Access Compliance Report Public Rights-of-Way (Curb Ramps)

Intersection ID: 10011236 Main Street: N_CHURCH_ST Cross Street: WADSWORTH PL Location: Ε ADA ID: 9AA60D5C6550 Ramp Type: Directional1 Initial Pass/Fail: Pass **Overall Compliance: No Severity Score:**

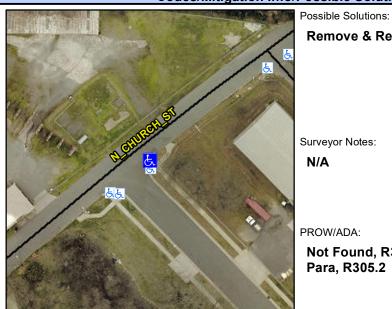
Remove & Replace Entire Ramp. Surveyor Notes: N/A PROW/ADA: Not Found, R304.2.2-Perp, R304.3.2-Para, R305.2
